MFN 06-215 Supplement 1

**Subject: Response to Portion of NRC Request for Additional Information
Letter No. 33 - Containment Systems - RAI Number 6.2-53 S01**

Related to ESBWR Design Certification Application

RAI Number 6.2-53 S01

Figure 6.2-53S01-1: DCD TRACG Nodalization of the ESBWR RPV

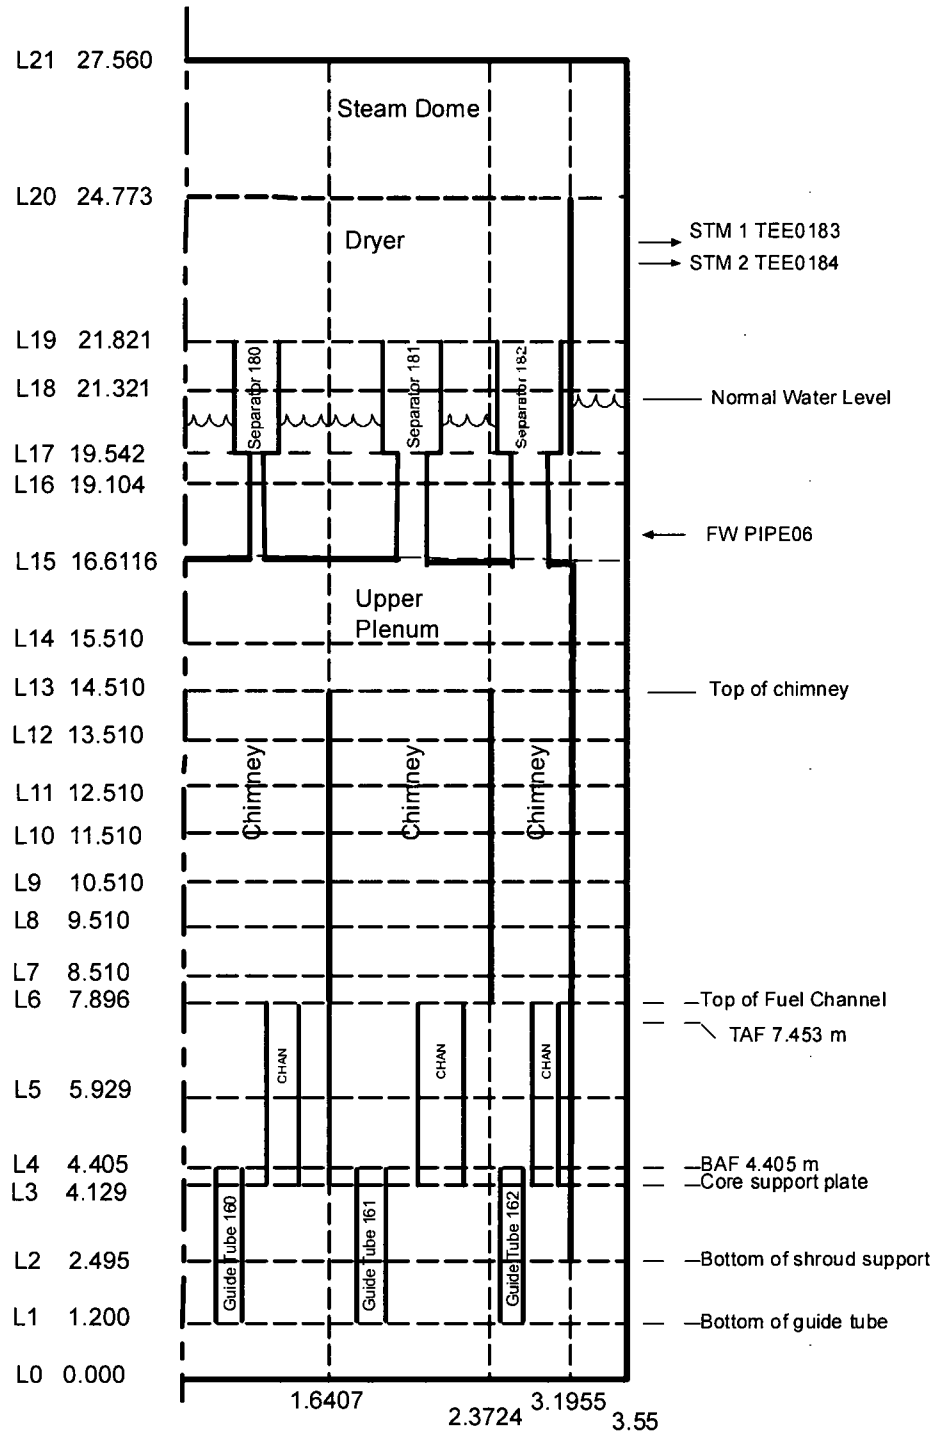
- (1) include the current limiting DBA of main steam line break accident,*
 - (2) reflect the modeling changes stated in GENE letter MFN 06-364 in response to RAI 6.2-59, and*
 - (3) include graphs for non-condensable gas pressure in wetwell versus time.*
- Update DCD Tier 2 to provide this information.*

In DCD Tier 2, Revision 3, the TRACG nodalization for the containment evaluation was modified to address the earlier comments from the NRC reviewers. The flow path between the Gravity Driven Cooling System (GDCS) air space and the drywell (DW) annulus was changed from 1-pipe connection to 2-pipe connection. This modification was to promote flow circulation and to purge the residual non-condensable (NC) gases in the GDCS pool air space.

Referring to the TRACG nodalization (Figures 6.2-53S01-1 and 6.2-53S01-2), the broken main steam line is located at Level 34 and discharges steam to the DW at this elevation. In

the DCD Tier 2, Revision 2 evaluation, the MSL steam break flow was assumed to discharge at Level 23 (in the DW region below the reactor pressure vessel (RPV) bottom) and to force the NC gases in the DW to transfer into the wetwell (WW). Parametric cases are performed to assess the impact of the discharge location for the steam break flow.
